STAFF REPORT

PLANNING & ZONING COMMISSION

1. PRELIMINARY DEVELOPMENT PLAN REVIEW

2. CERTIFICATE OF APPROPRIATENESS REVIEW

Ideal

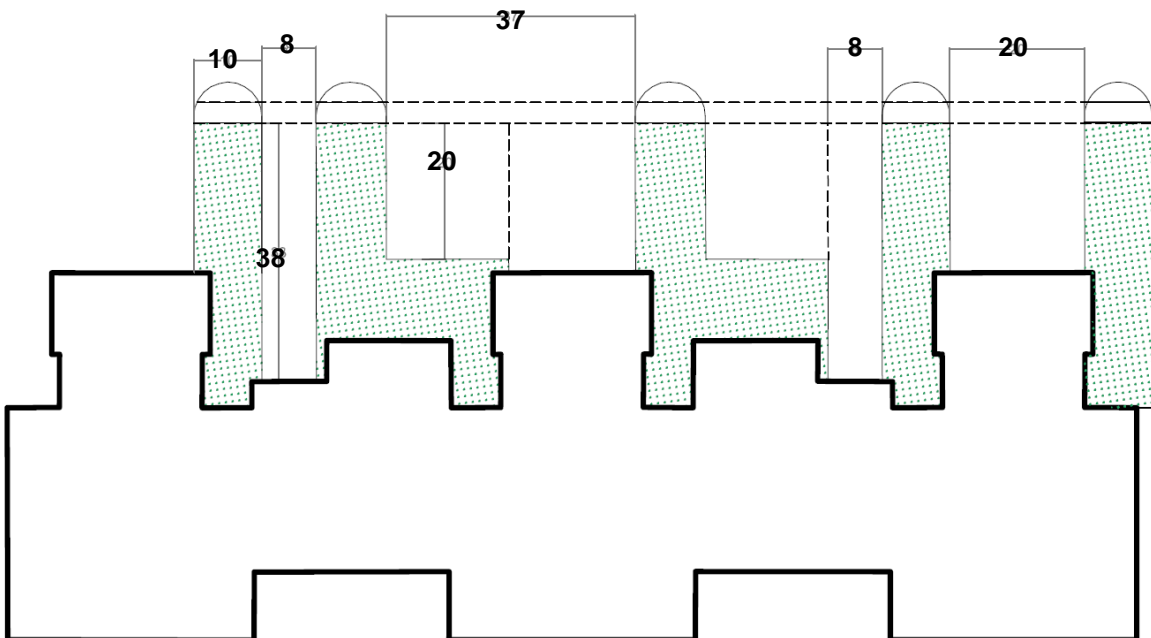
Staff just received the Traffic Study on Friday. We will update this report later. Staff does have an issue with the interior sidewalk plan related to the depth of parking driveways for the townhomes. The depth of parking areas are not deep enough. See the images on the next page. We need the applicant to pinch the rear of the townhome buildings a few feet closer together to create better parking situation where the parking does not interfere with sidewalks.

Signage and Graphics (PAG, P. 274)

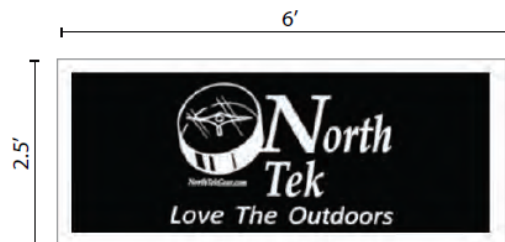
- The applicant provided a signage design that meets all of the PAG except that the size of the larger sign is too big and both signs are aluminum.
 - Overall size should not exceed 12 square feet in the Historic District.
 - The proposed sign is 24 square feet.
 - Wood is the preferred material for signs.
 - Staff defers to the Commission for their opinion.
